December 28, 2004  
LIC-04-0132

**SUBJECT: Response to Request For Additional Information Concerning the 2003 Steam Generator Inservice Inspection Reports**

### Response to Request For Additional Information Concerning the 2003 Steam Generator Inservice Inspection Reports

Eggcrate and Tube Support Plate Intersection –  
Bottom View with Maximum Stress and Crack Locations

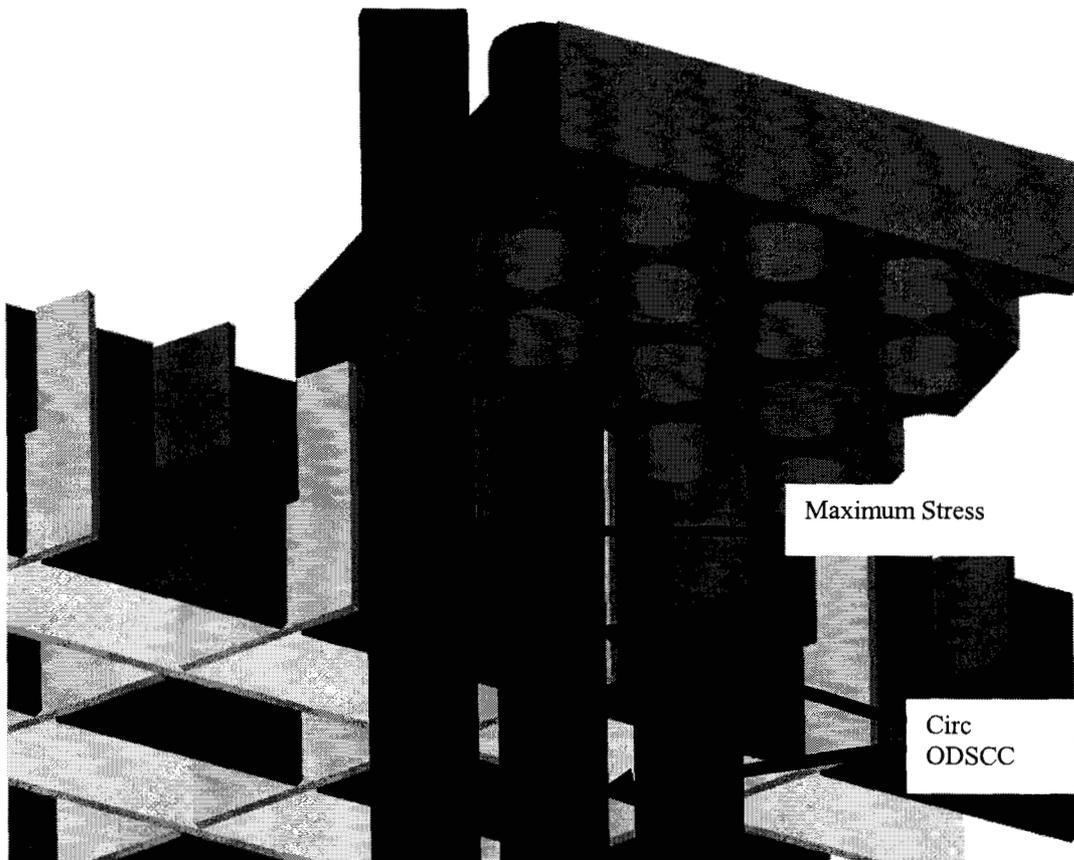
In steam generator B, a single circumferential indication (SCI) was located at the seventh eggcrate support and four SCIs were located in the freespan (areas not encompassed by a support structure). Please discuss any unique circumstances, including dents, associated with these indications and discuss the implications for future susceptibility of the eggcrate supports and freespan region to circumferentially oriented degradation.

A root cause analysis was conducted after the inspection. The indication identified at the eggcrate support is at the chord region (edge) of the partial drilled support plate (see UT results for SG B Row 84 Line 73 listed above in question #1). A second tube (also in the chord region) with a circumferential indication at an eggcrate location was detected in SG B (R87/L52) at support H4 – 1.10". This support structure is also a combination eggcrate / drilled plate assembly. The indication is 0.27 volts with an estimated depth of 33% and an arc length of 21 degrees. The three coil delta probe confirms the presence and orientation of the flaw. The low frequency pancake coil data shows that the flaw is located below the tube support plate and the azimuthal orientation of the flaw is about 120 degrees relative to the eggcrate lattice. Only one lattice bar is evident in the ECT data. This intersection was not included in those tested by UT.

At the top of these eggcrates along the chord the edge of the drilled plate is scalloped and has the shape of a series of semi circles when viewed from the top. Growth of the drilled plate from denting results in a bending strain at and below the eggcrate where the tube is restrained from movement in the lateral plane. This configuration is unique to the chord region and these locations have been identified as a critical area in accordance with EPRI guidelines. The February 2005 examination will include plus point coil testing of 100% of this critical area.
